**IMPORTANT MEDICAL DEVICE SAFETY ALERT****Medtronic HeartWare™ HVAD™ System**

Product	Models
HVAD™ Pump Outflow Graft	1125
HVAD™ Pump Implant Kit	1103
HVAD™ Implant Accessories Kit	1153

April 2020

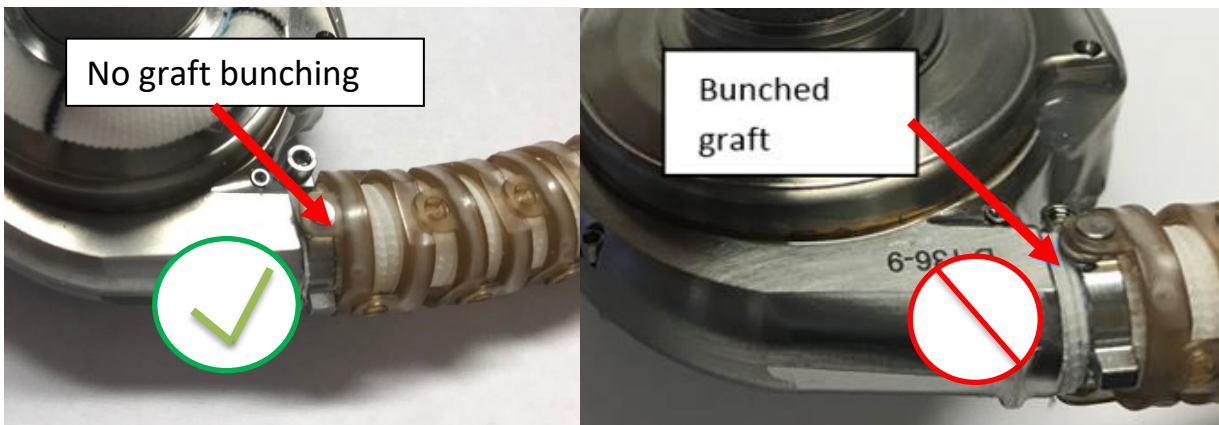
Avoid "bunching" of graft corrugations between the strain relief clamp and the pump body.

While maintaining the fully loosened strain relief clamp over the pump outflow conduit, gently pull on the outflow graft to reduce corrugation bunching between clamp and pump body. Extra corrugations from the graft may prevent the strain relief clamp from being flush against the pump body, leading to the strain relief clamp being positioned over the pump outflow conduit ridge, potentially resulting in graft laceration while tightening.
